Proposal Request

PROJECT: *(name and address)*
AWSOM
Bentonville, Arkansas

PROPOSAL REQUEST 097

BBH RFIs

① PIPING - LEVEL 1 PLAN - AREA B
1/8" = 1'-0"

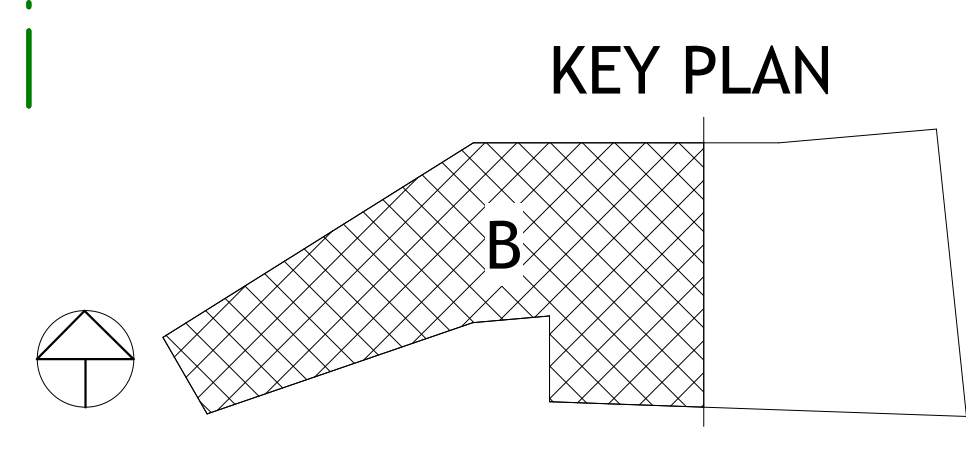
- a) Refer to Revised Sheet **M201B**, Detail 1, with original issue date 02.24.2023 and revised date 11.15.2024.
 - Revise BBH 12, 60, and 61 design in response to RFI 509.

1 PIPING - LEVEL 3 PLAN - AREA A
1/8" = 1'-0"

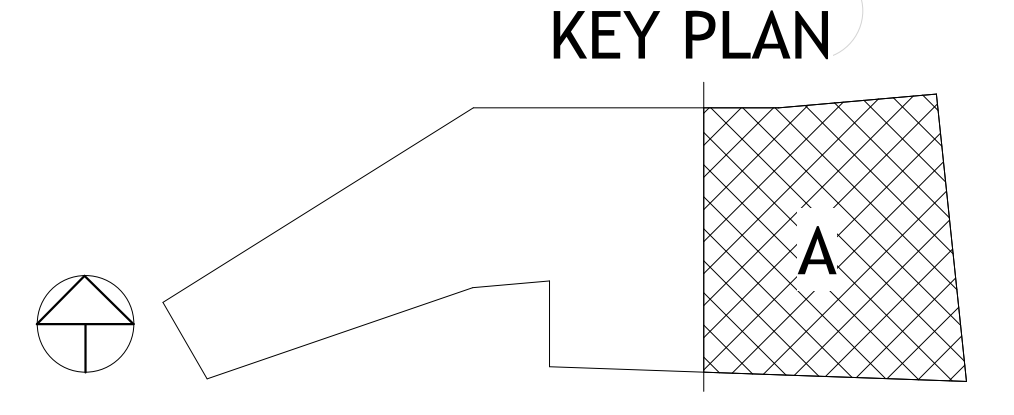
- b) Refer to Revised Sheet **M203A**, Detail 1, with original issue date 02.24.2023 and revised date 11.15.2024.
 - Revise baseboard heater design for units 76-120 to remove blankoff units. Various units were either removed from the design or resized and made active to address RFI 505.

- Revise baseboard heater 76 size in response to RFI 519.
 - Revise BBH sizes for 108-120 in response to RFI 514.
 - Remove piping associated with BBH 153 and 155 in response to RFI 510.

1 PIPING - LEVEL 4 PLAN - AREA A
1/8" = 1'-0"

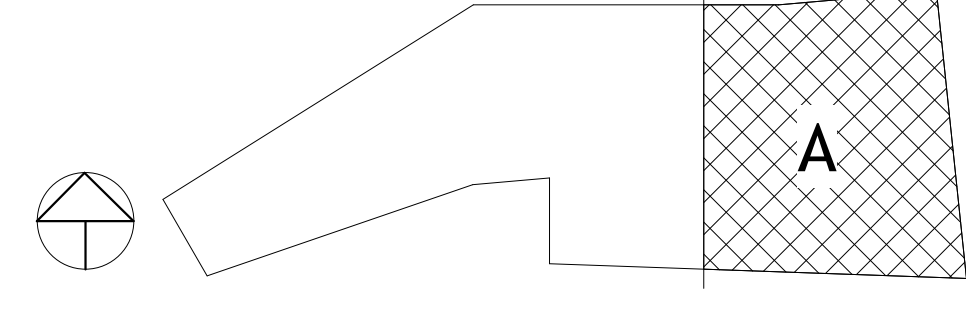
- c) Refer to Revised Sheet **M204A**, Detail 1, with original issue date 02.24.2023 and revised date 11.15.2024.
 - Revise baseboard heater design for units 121-144, 148-155 to remove blankoff units. Various units were either removed from the design or resized and made active to address RFI 505.

- Remove BBH 153 and 155 in response to RFI 510.
- d) Refer to Revised Sheet **M603**, BASEBOARD HEATER SCHEDULE, with original issue date 02.24.2023 and revised date 11.15.2024.
